UNITED STATES DEPARTMENT OF COMMERCE United States Patent and Trademark Office Address: COMMISSIONER FOR PATENTS P.O. Box 1450 Alexandria, Virginia 22313-1450 www.uspto.gov

| APPLICATION NO.   | FILING DATE                        | FIRST NAMED INVENTOR | ATTORNEY DOCKET NO. | CONFIRMATION NO. |
|-------------------|------------------------------------|----------------------|---------------------|------------------|
| 10/574,183        | 10/03/2006                         | Rainer Bader         | T55120002           | 7462             |

| Office Astion Communication  |   | Aı   | oplication No.  | Applicant(s)   | Applicant(s) |  |  |  |
|--|---|--|---|--|--------------|--|--|--|
| Office Action Summary  |   |  | kaminer   | Art Unit   |              |  |  |  |

#### **DETAILED ACTION**

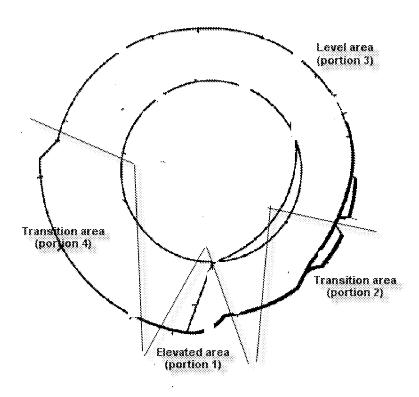
Applicant's arguments filed 1/14/2010 have been fully considered but they are not persuasive. The Applicant contends that the Otto et al. reference lacks a plurality of transitional areas that would allow the rim surface of the invention to be divided into at least four portions. The examiner respectfully disagrees. Otto et al. discloses two transitional areas on either side of peak (40). Please see the figures below for further clarification.
